ORIGINATION FORM

Proposed Revisions to a Standard Plans Index
(Please provide all information — Incomplete forms will be returned)

Index Number: 515-062
Sheet Number (s): 6
Index Title: Pedestrian/Bicycle Railing (Aluminum)

Summary of the changes:

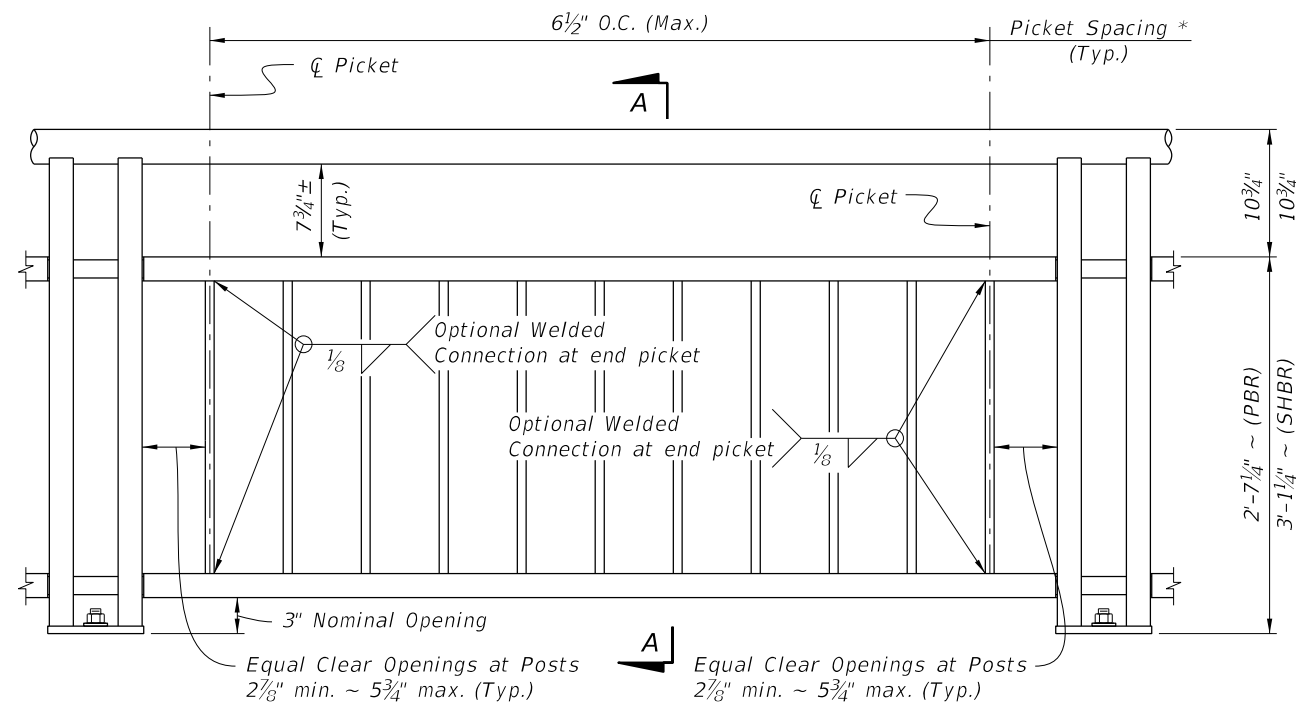
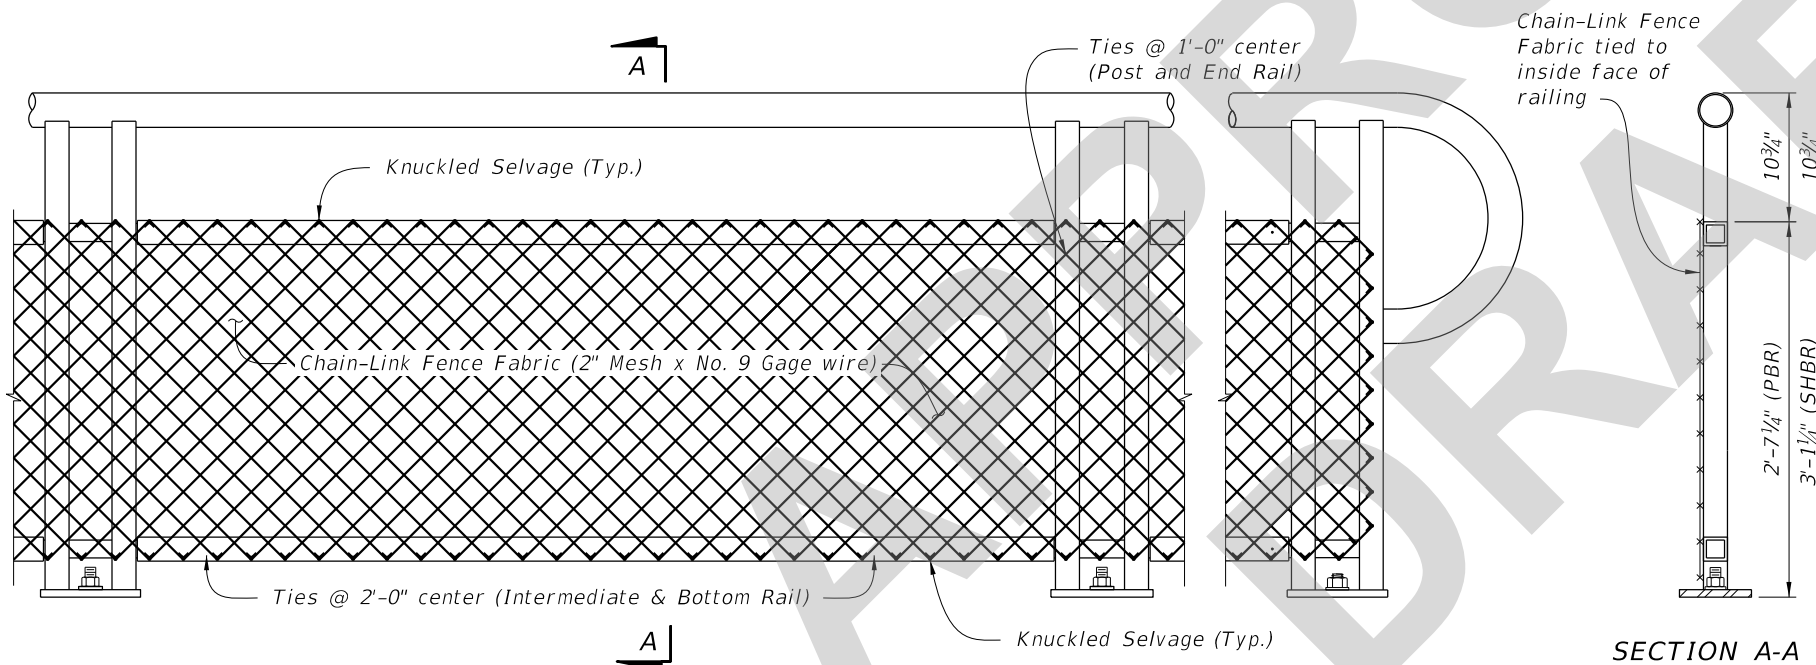
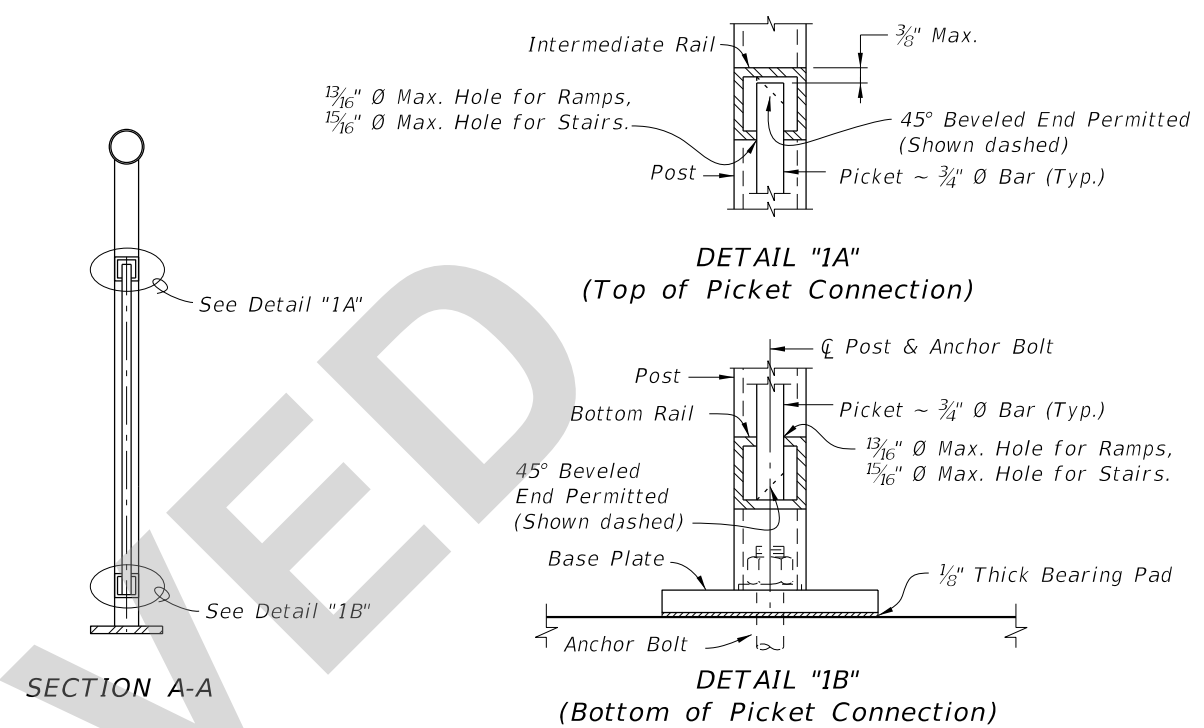
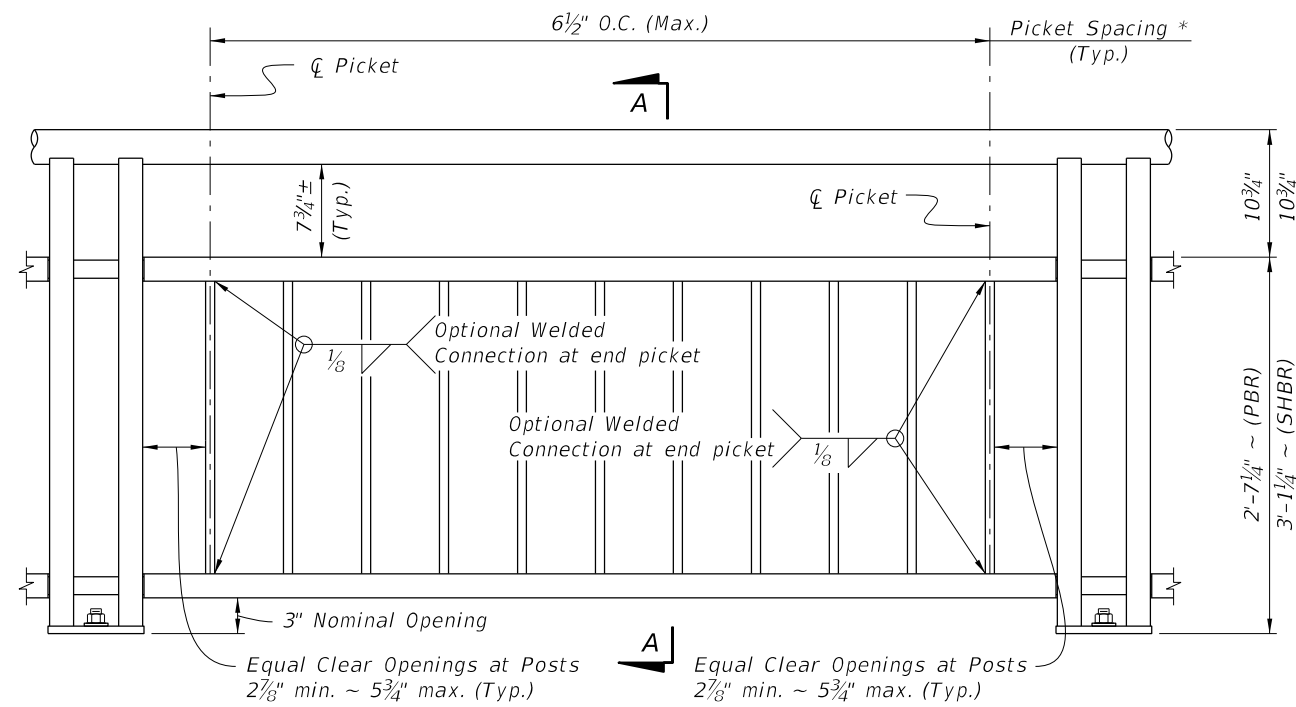
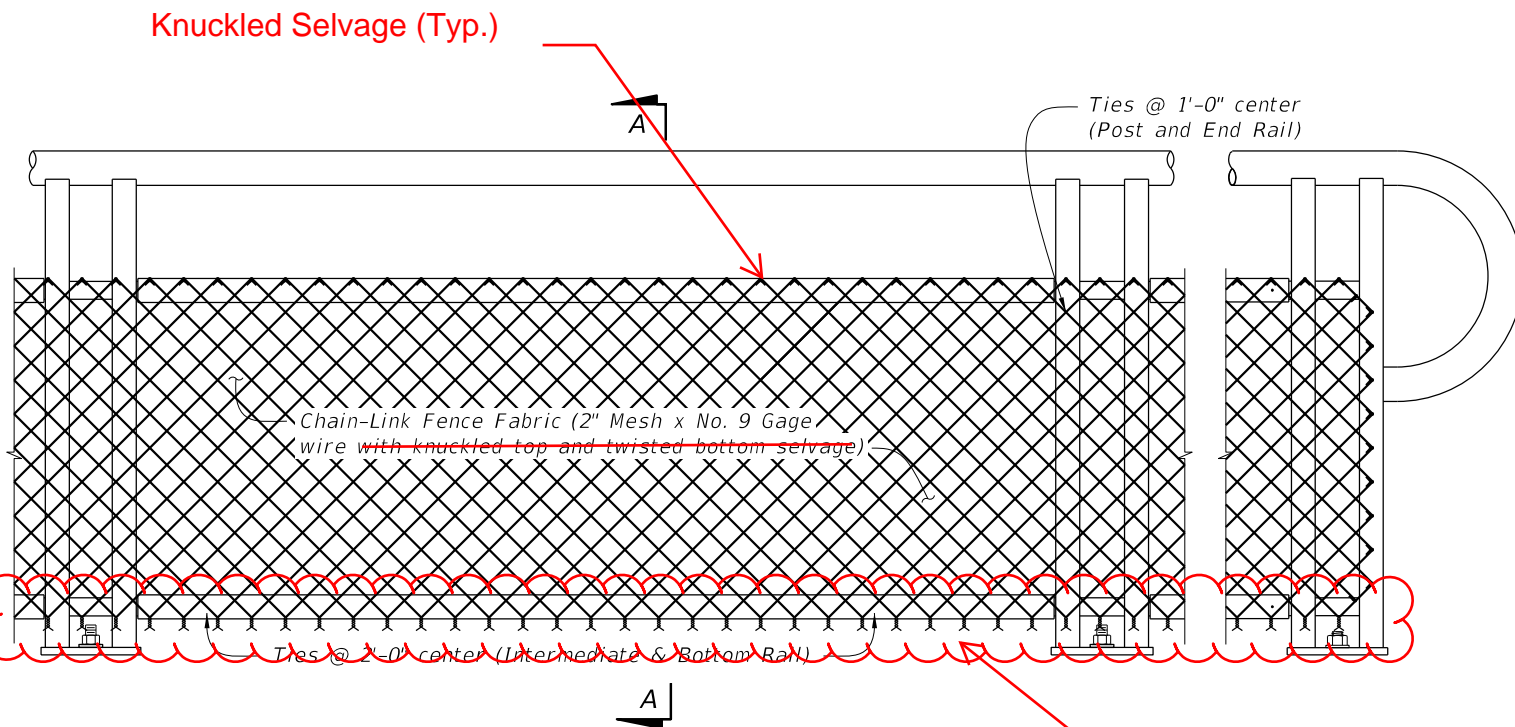
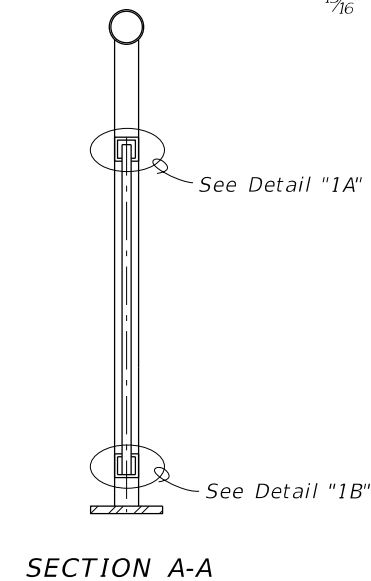
Sheet 6- Added knuckled selvage as an option to the chain-link railing option

The selvage requirements detailed on Index 515-062 were based on a conservative approach to secure the bottom edge. Using knuckle selvage top and bottom would be acceptable.

TABLE 2 - CHAIN-LINK PANEL COMPONENT MATERIALS		
COMPONENT	ASTM	COMPONENT INFORMATION
Chain-Link Fence Fabric (2" mesh with knuckled top and bottom selvage)	A392	Zinc-Coated Steel - No. 9 gage (coated wire diameter), Class 2 Coating
	A491	Aluminum-Coated Steel - No. 9 gage (coated wire diameter)
	F668	Polyvinyl Chloride (PVC) Coated Steel - No. 9 gage Zinc-Coated Wire (metallic-coated core wire diameter) ~ See Plans for specified color of PVC.
Tie Wires	F626	Zinc-Coated Steel Wire - No. 9 gage with coating to match Chain-Link Fence Fabric.
Tension Bars	F626	3/16" (min. thickness) x 3/4" (min. width) x 2'-3' (min. height) Steel Bars
Miscellaneous Fence Components	F626	Zinc-Coated Steel
